SUBJECT: CORRECTION TO AMENDMENT NO. 19

RE: LIMERICK GENERATING STATION, UNIT 1

In Amendment No. 19, page 3/4 2-9 should have included reference to two figures revised as part of the reload. A corrected copy of this page which now is exactly as contained in your submittal of January 27, 1989, is enclosed.

FIGURE 3.2.3-1a

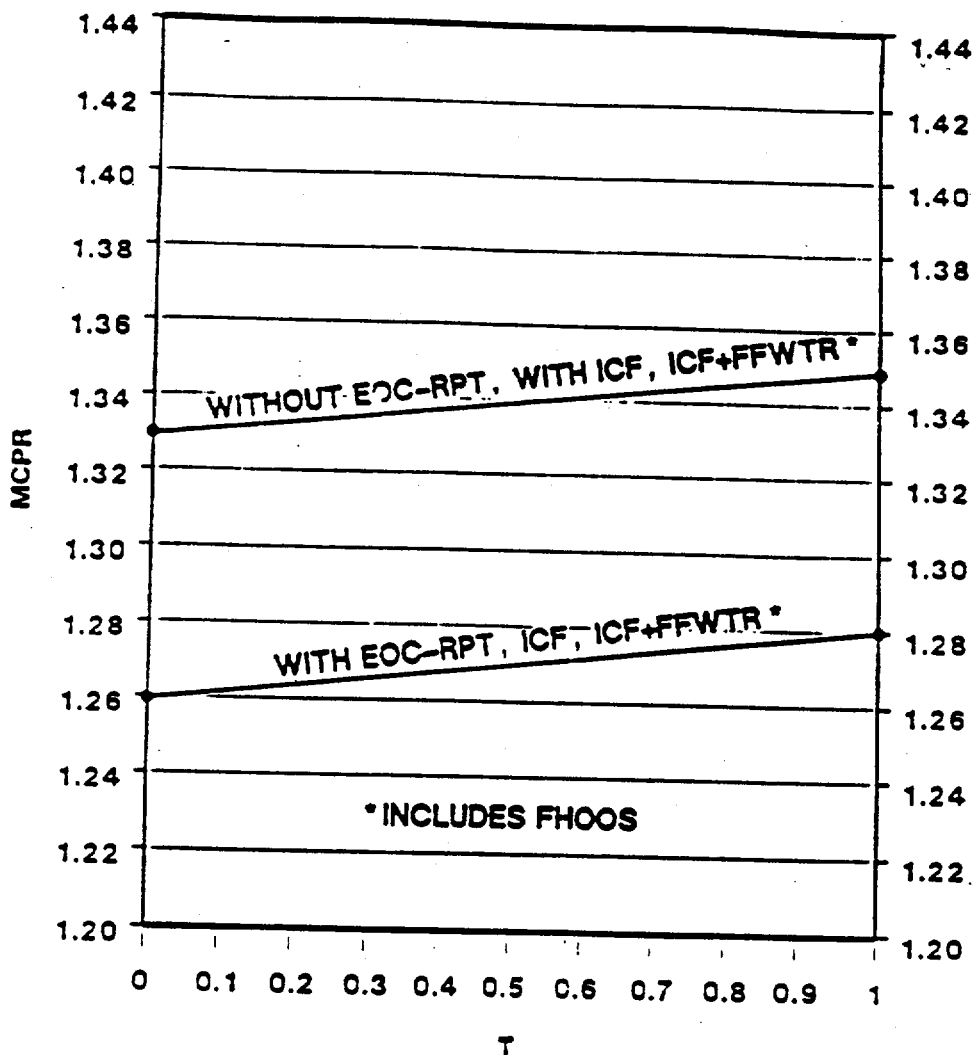
shall be determined to be equal to or greater than the applicable MCPR limit determined from Figures 3.2.3-1a, 3.2.3-1b, 3.2.3-1c, 3.2.3-1d and 3.2.3-2.
